COLLETON CROSSING SUBDIVISION

AIS SUBDIVISION - CONDITIONAL USE PERMIT TALLY HO TRAIL/REYNARD ROAD CARRBORO, NORTH CAROLINA

Background, Concept Plan Development

LANDSCAPE PLAN
COLLETON CROSSING
AIS SUBDIVISION

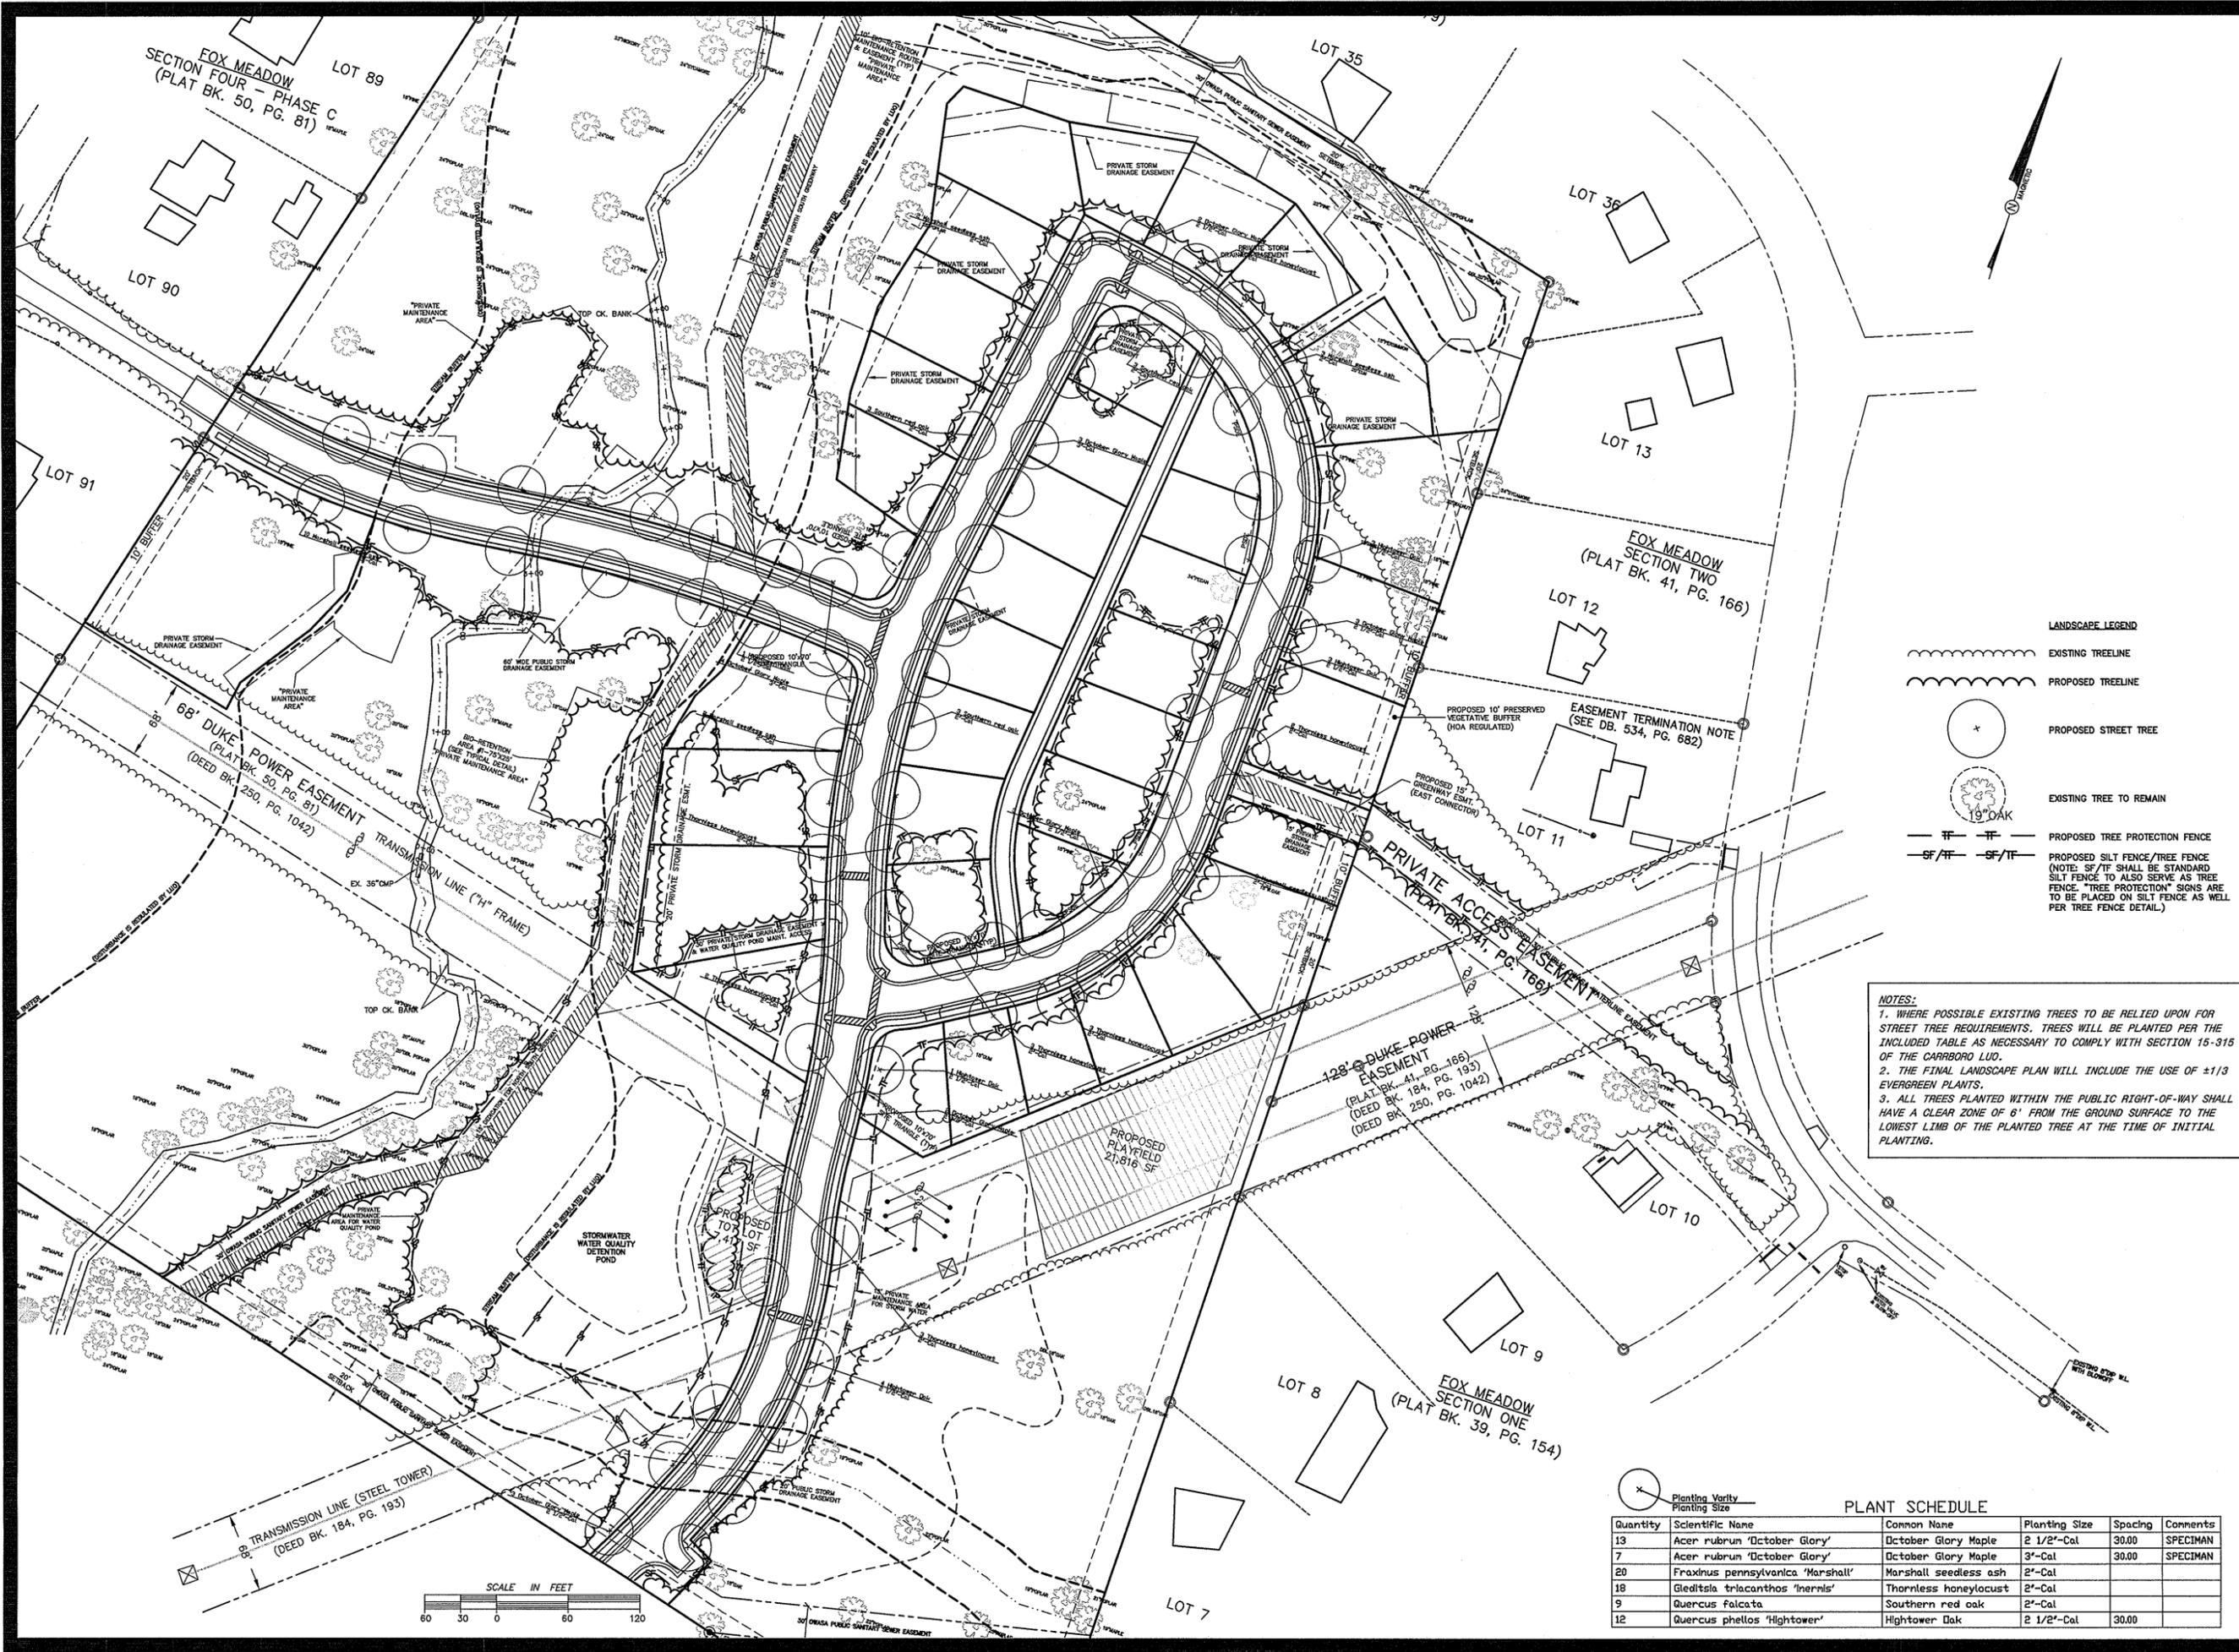
R/W and exceed the provisions of Section 15-315 (which requires street trees be spaced an interval of at least one tree per 100 feet). However, the street trees are not *irregularly* spaced as required by this ordinance. Additionally, the landscape plan satisfies the Town policy requiring 1/3rd of all trees be evergreen. Because of this the following condition is recommended:

- That, prior to construction plan approval the proposed street tree planting layout be revised to meet the spacing requirements of Section 15-315 of the LUO and that 1/3rd of the proposed street trees be evergreen.

9. That, prior to construction plan approval the proposed street tree planting layout be revised to meet the spacing requirements of Section 15-315 of the LUO and that 1/3rd of the proposed street trees be evergreen.

CONSERVATION & RECREATION PLAN
COLLETON CROSSING
AIS SUBDIVISION
TOWN OF CARRBORO
ORANGE COUNTY, N.C.

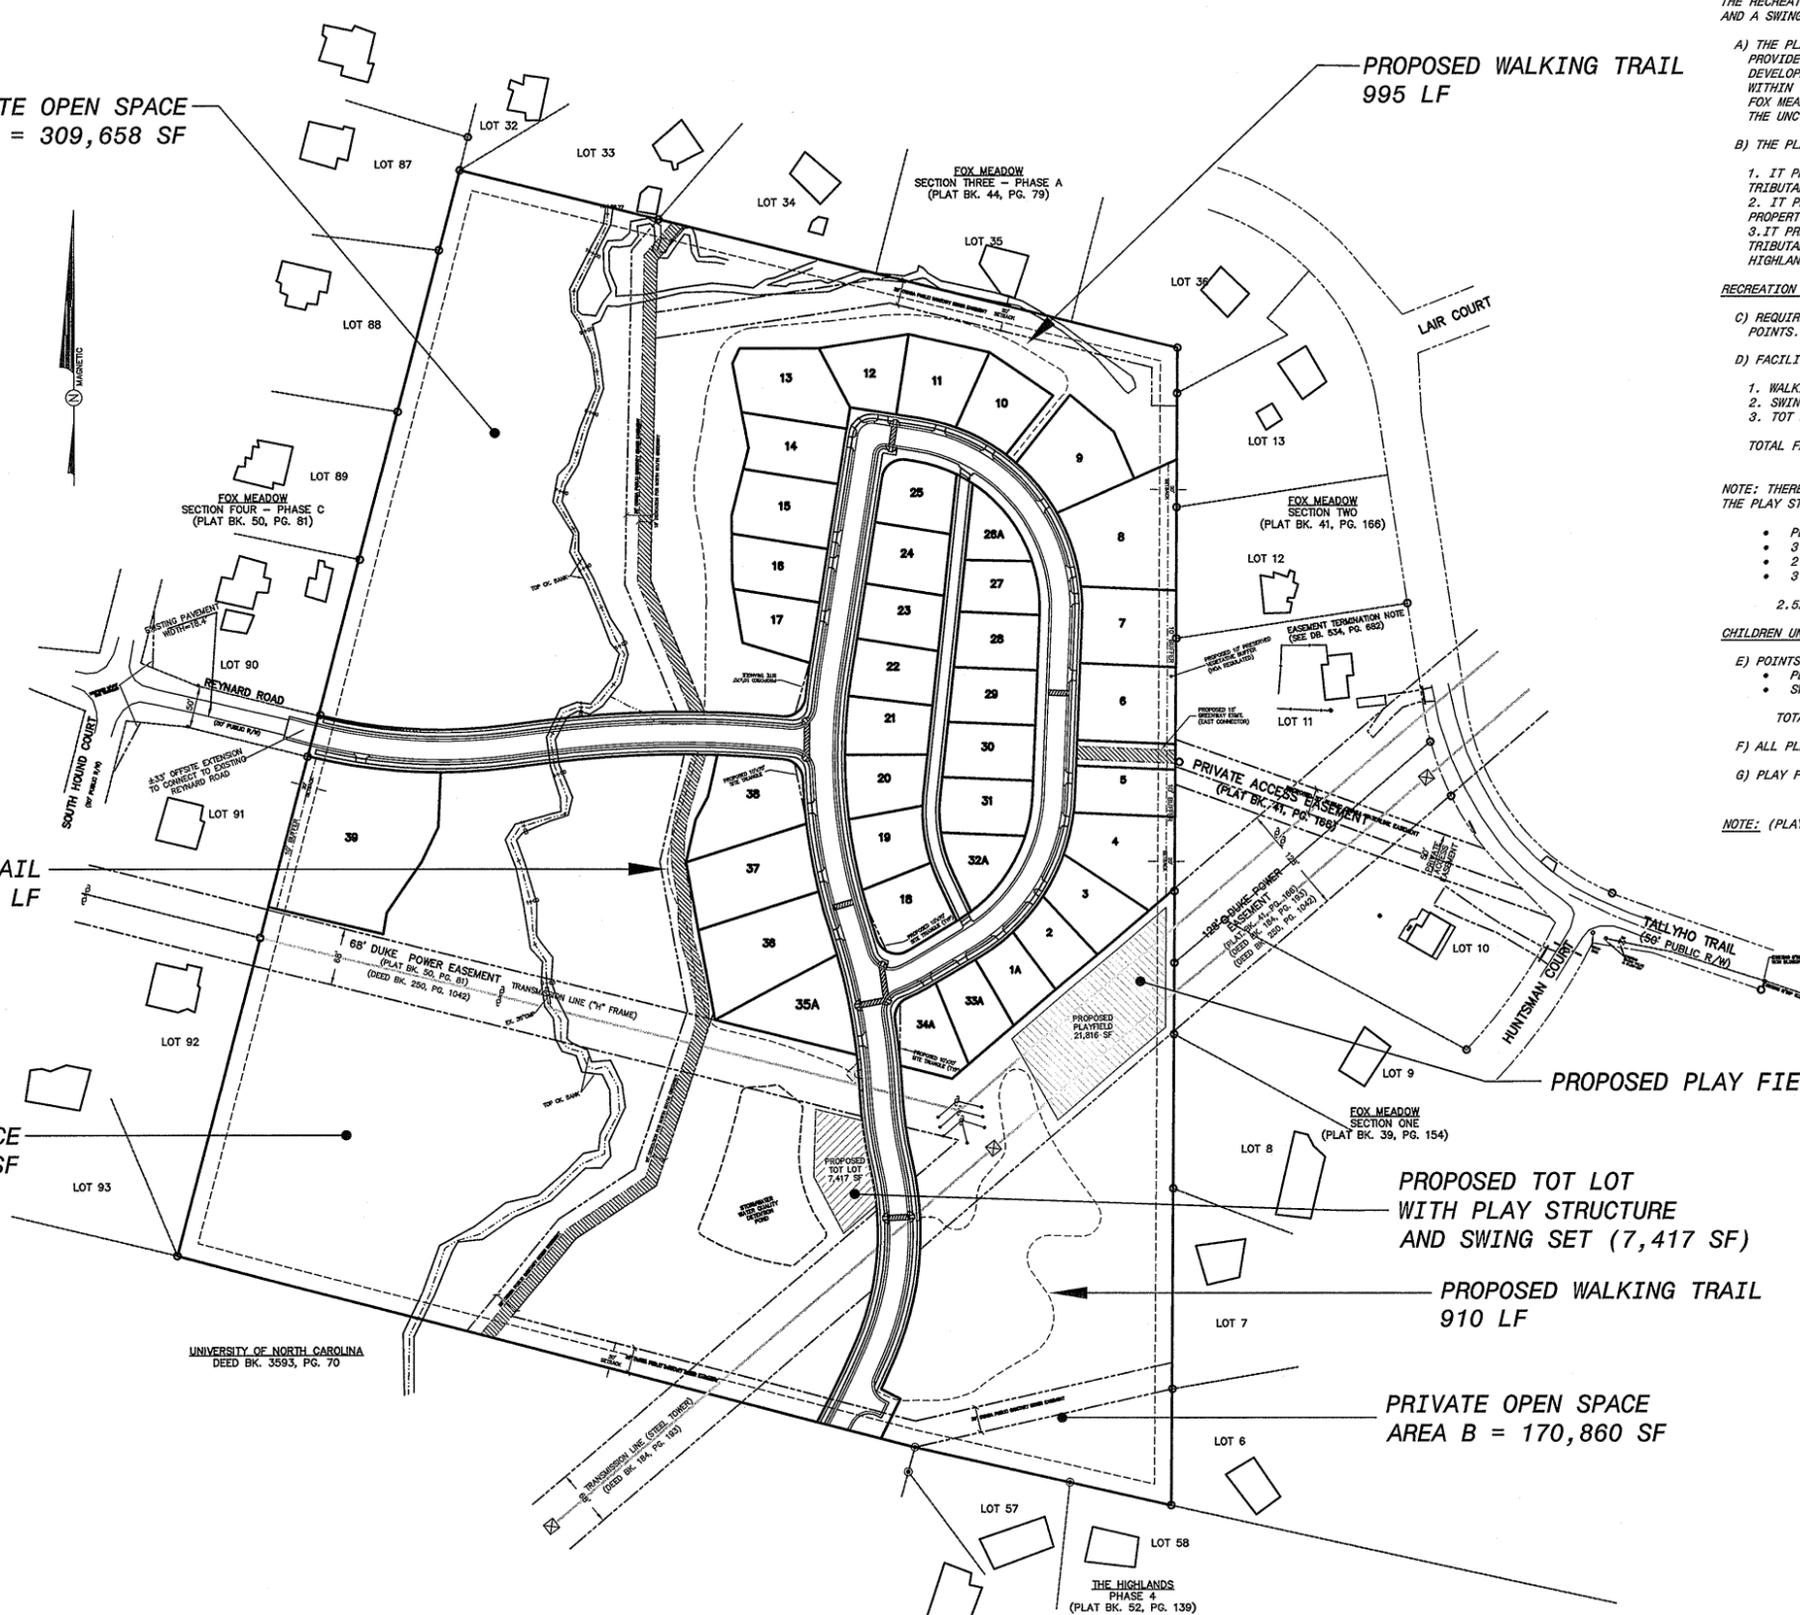
- That, prior to construction plan approval, the proposed greenway alignment from the southern property line be realigned to follow the OWASA easement behind lots 36 -38 so as to tee in to Reynard Road.

- That, in the construction plans the greenway trails be designed to meet or exceed the specifications identified in the AASHTO Guide for the Development of Bicycle Facilities, and that the proposed greenway be constructed to the Type IV AASHTO standard.

6. That, prior to construction plan approval, the proposed greenway alignment from the southern property line be realigned to follow the OWASA easement behind lots 36 -38 so as to tee in to Reynard Road.

7. That, in the construction plans the greenway trails be designed to meet or exceed the specifications identified in the AASHTO Guide for the Development of Bicycle Facilities, and that the proposed greenway be constructed to the Type IV AASHTO standard.
